SUBJECT: CYCLE 6 RELOAD, SUSQUEHANNA STEAM ELECTRIC STATION, UNIT 2 (PLA-3787
AND PLA-3810) (TAC NO. M83988)

Enclosure:
Revised Page 3/4 2-2 for
Amendment No. 91

**MAXIMUM AVERAGE PLANAR LINEAR HEAT
GENERATION RATE (MAPLHGR) VERSUS
AVERAGE BUNDLE EXPOSURE
SNP 9X9 FUEL
FIGURE 3.2.1-1**

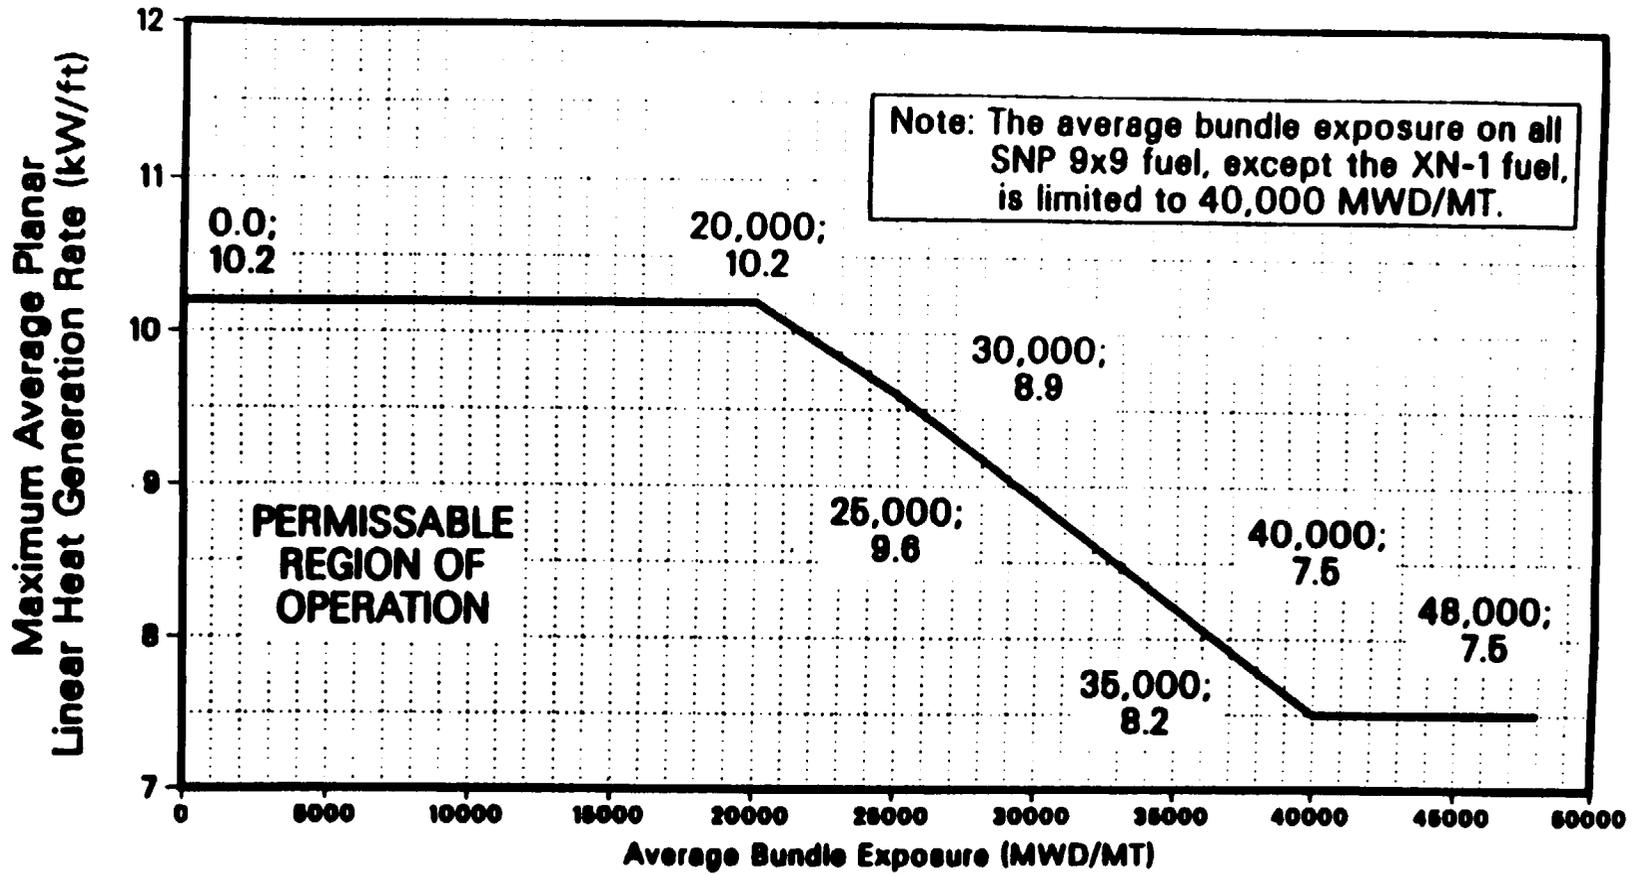
By letter dated October 28, 1992, the Commission issued Amendment No. 91 to Facility Operating License No. NPF-22 for the Susquehanna Steam Electric Station, Unit 2. Page 3/4 2-2, Figure 3.2.1-1 issued with Amendment No. 91 was that submitted by your application of June 30, 1992, rather than the revised Figure 3.2.1-1 submitted by your letter of July 21, 1992. Enclosed is the correct page 3/4 2-2 with the note added to Figure 3.2.1-1 along with overleaf page 3/4 2-1.

Note: The average bundle exposure on all SNP 9x9 fuel, except the XN-1 fuel, is limited to 40,000 MWD/MT.
